Level 1 Floorplan

Modifications

01 West Elevation
Scale 1:200

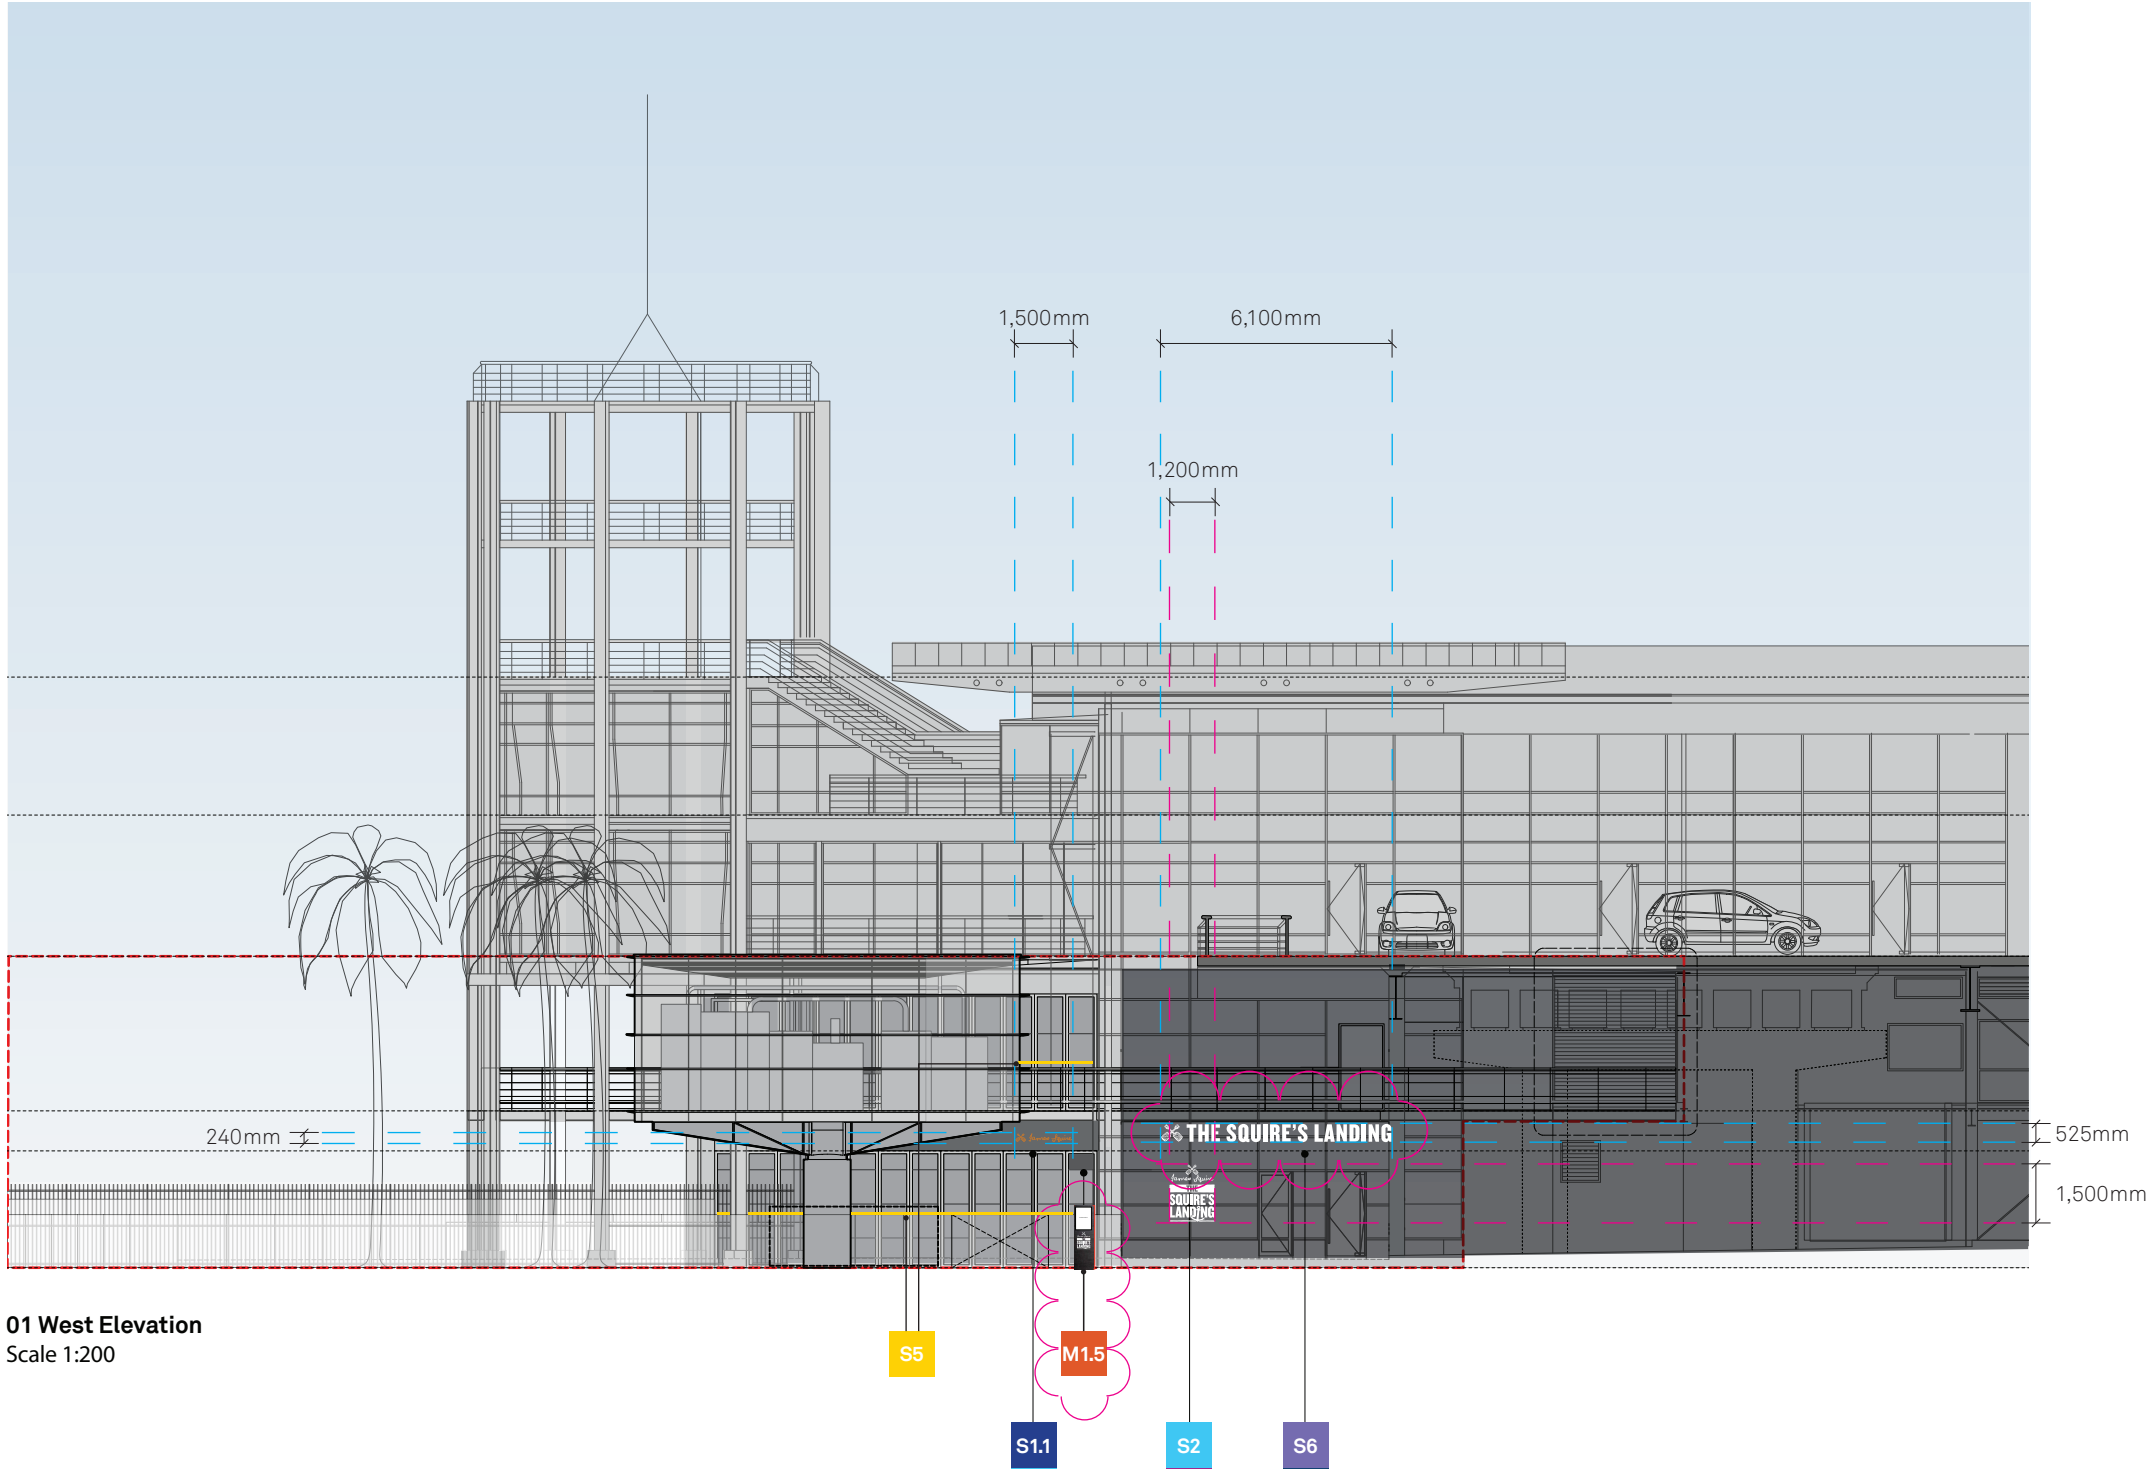
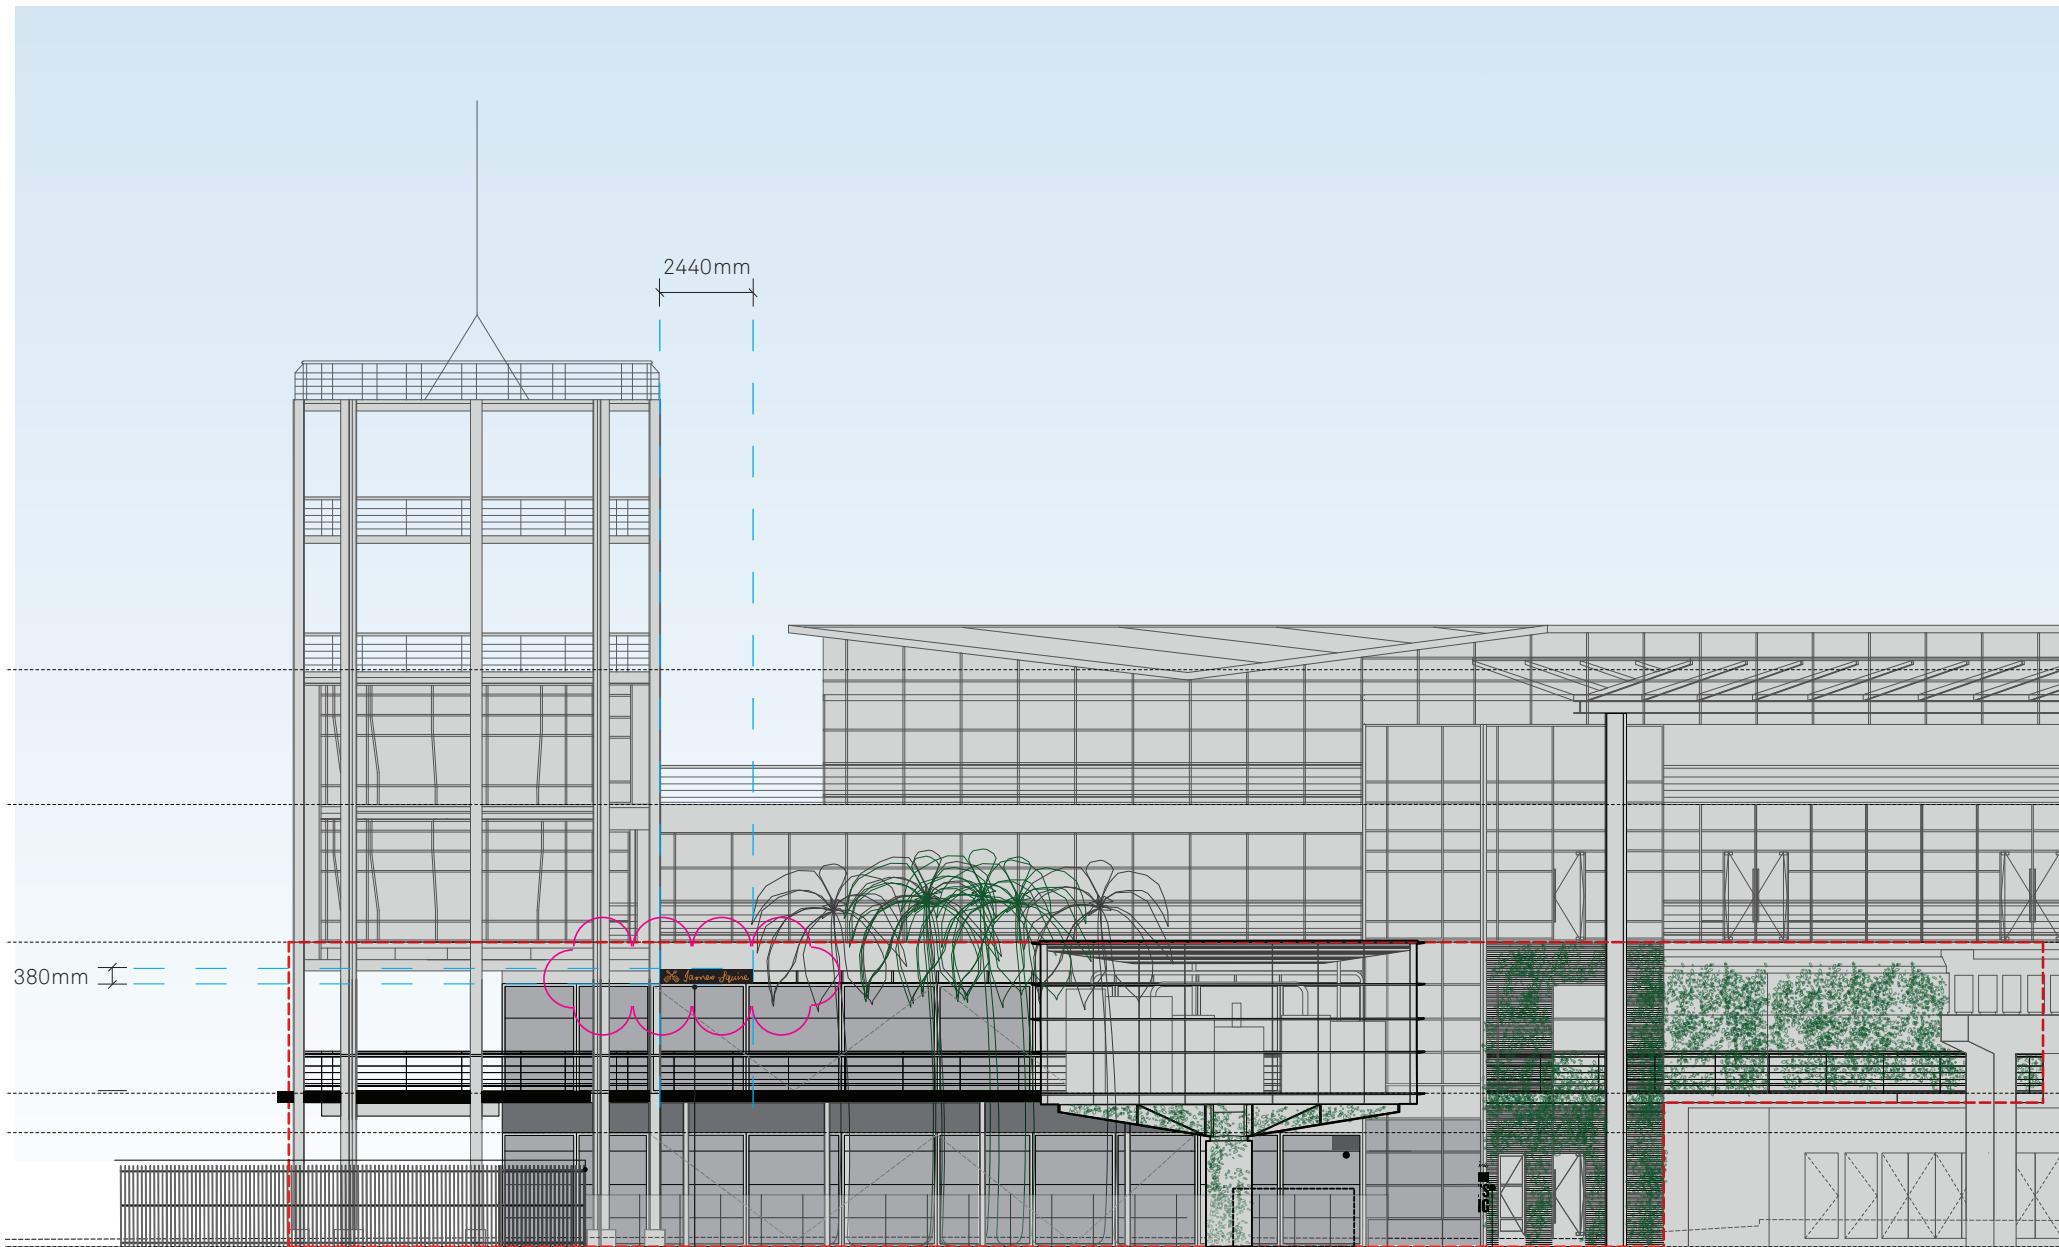
-  **M1** Menu Stand
Freestanding menu stand with illuminated logo and menu
-  **S6** The Squire's Landing identification
New sign Level 2 balcony. Sign is illuminated.
